**HOWARD COUNTY HEALTH DEPARTMENT  
BUREAU OF ENVIRONMENTAL HEALTH  
WATER AND SEWERAGE PROGRAM  
TEL: (410)313-2640 FAX: (410)313-2648**

**Information Form for the Installation of the Well Pump, Pitless Adapter, and Supply Piping**

SITE INSPECTION SHEET

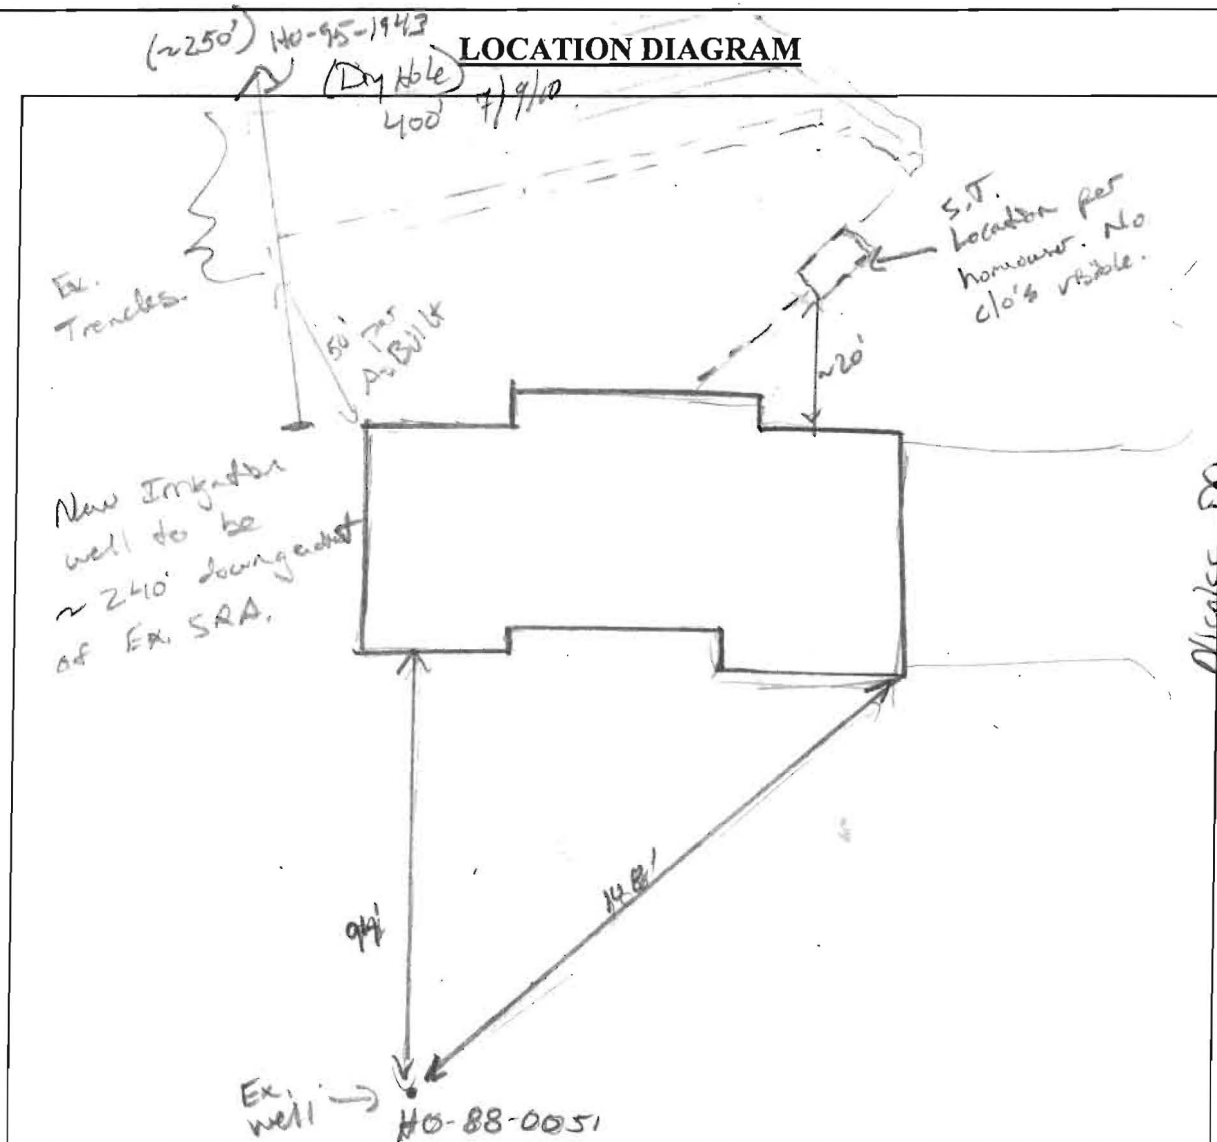
PROPOSAL: Want to drill irrigation well

COMMENTS: Irrigation well to be placed in very back part of property. Meets 200' down-gradient set back of SRA.  
7/9/10 see aerial map for Repl well locations (13)
